**Historic Architectural Review Commission
Staff Report for Item 10**

Application Number: H2018-0022

Address: #1021 Fleming Street

Removal of non-historic side addition at garage. Demolition of rear non-historic porch at main house.

1962 Sanborn Map

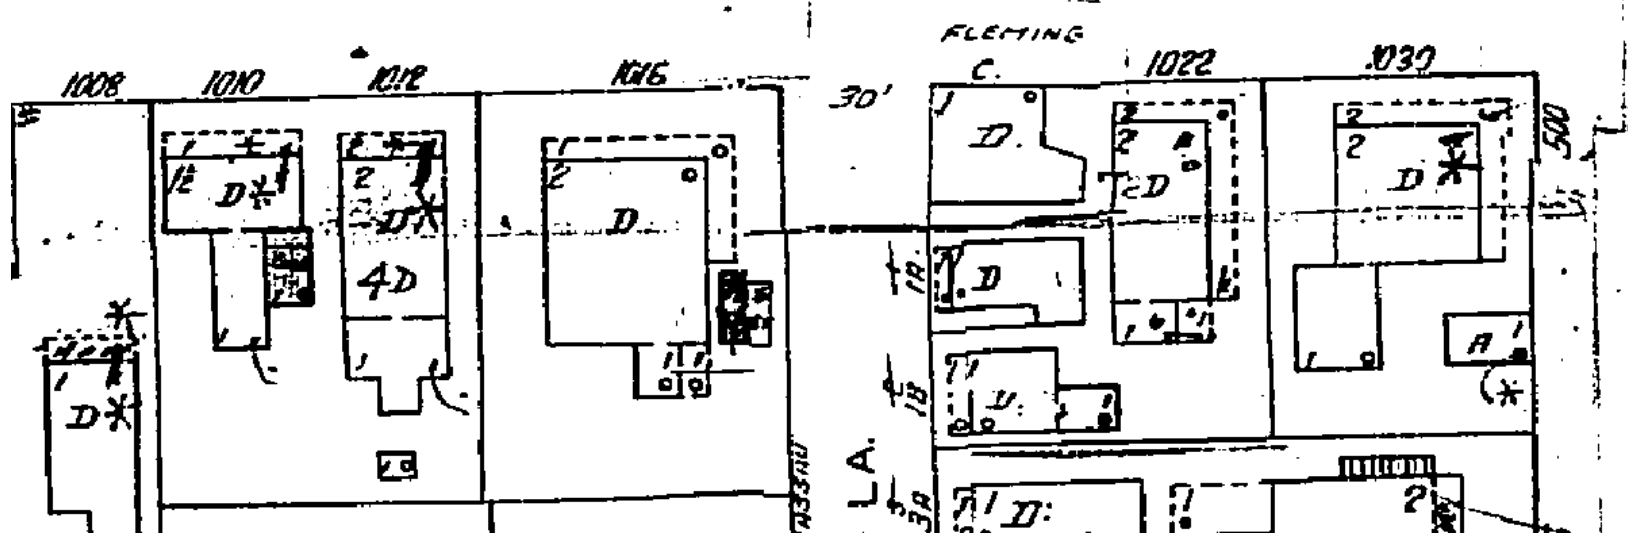
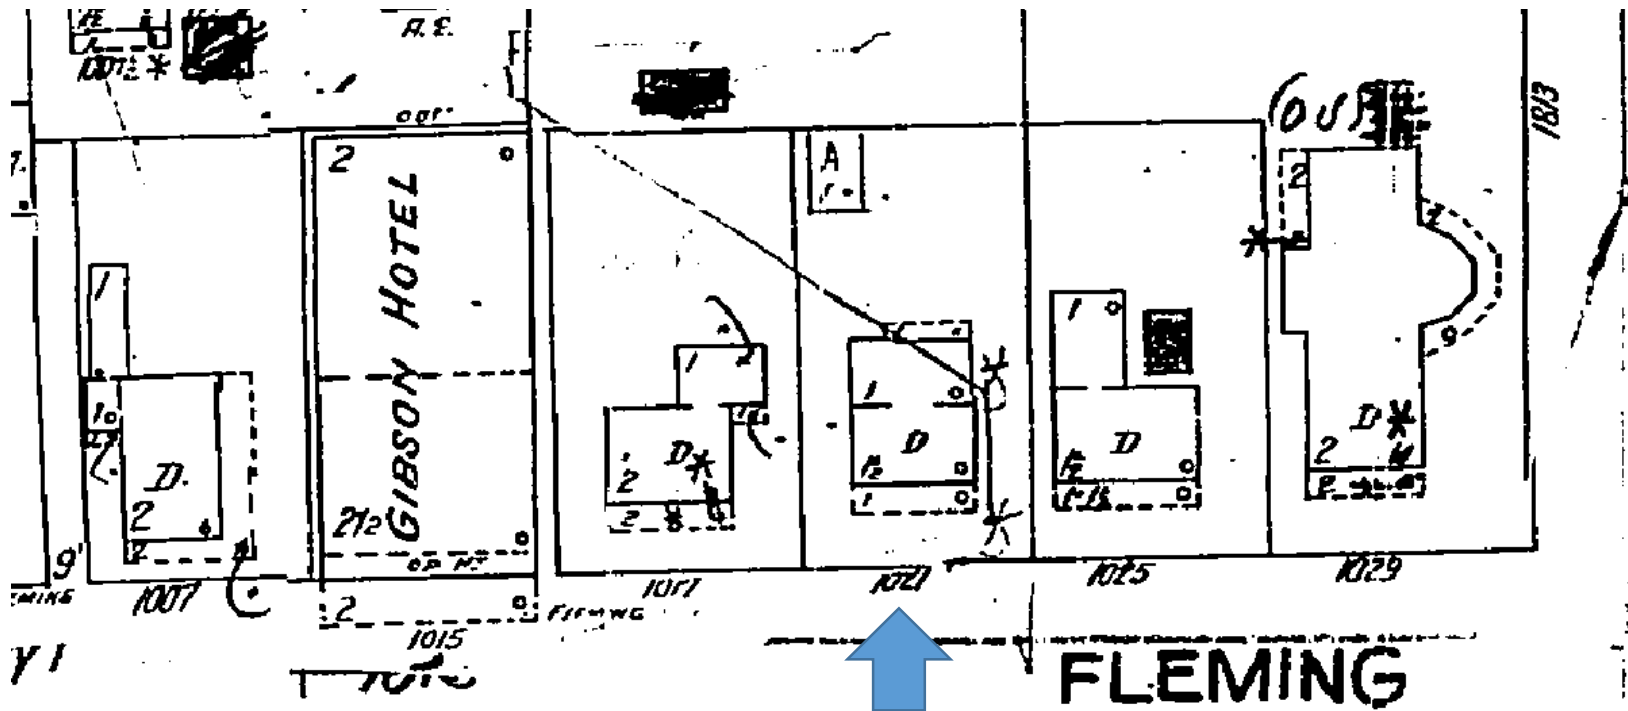
The one-and-half-story, frame vernacular structure is listed as a contributing resource. It was built c.1892 per the survey. The garage in the rear first appeared on the 1962 Sanborn map. The rear covered porch does not show up on any Sanborn map and therefore is not historic. The historic garage has a non-historic addition on the left side.
